UNITED STATES PATENT AND TRADEMARK OFFICE

APPLICATION NO.	FILING DATE	FIRST NAMED INVENTOR	ATTORNEY DOCKET NO.	CONFIRMATION NO.
10/535,137	01/25/2006	Leif Andersson	15090NP	3586

NON-FINAL OFFICE ACTION

FIG. 3

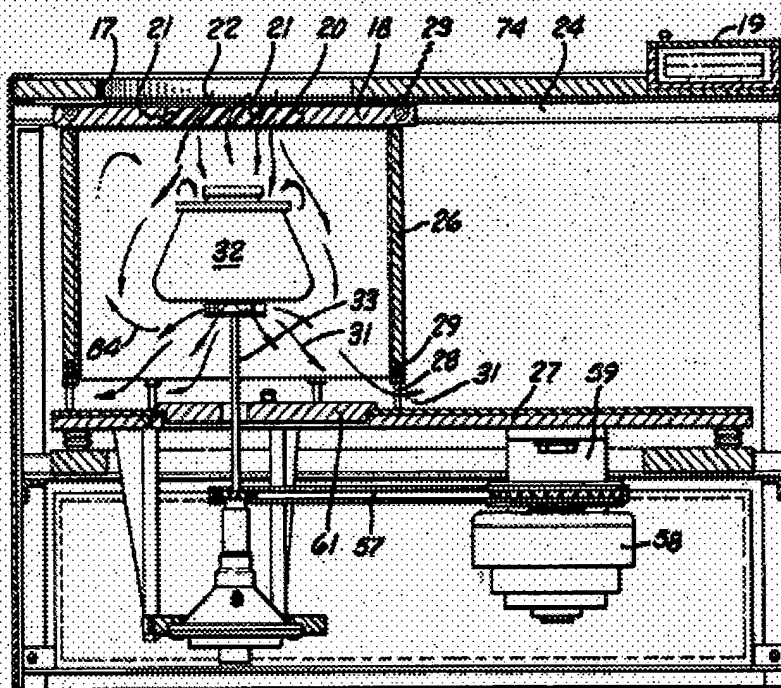
12. Claims 1-9, 11, and 13 are rejected under 35 U.S.C. 102(b) as being anticipated by Pickels et al. (US 2,878,992).

The patent to Pickels et al. discloses as seen below a device for centrifuging including rotor means 32 with thermal treating means for thermally treating centrifuging reaction vessels 89 containing samples in a thermocycling device; the rotor means 32 comprises at least one fan blade 71 and/or 83 which force ambient gas to through the rotor means and pass the samples; at least one gas conducting passage 69 is arranged in the rotor means 32; wherein the rotor means 32 comprises a base portion (above 82) and a lid portion 86, 87, in between which an inner space 69 is formed wherein the fan blades 71 and/or 83 are arranged; the lower region of the rotor means 32 is provided with at least one through hole (above 82); the upper region of the rotor means 32 is provided with at least one through hole 87; the fan blades 71 are arranged at the inside of the base portion of the rotor means 32; wherein the fan blades 71 are arranged at the inside of the lid portion 86, 87 of the rotor means 32; a plate 86; the gas is ambient air (col. 3, lines 41-49).
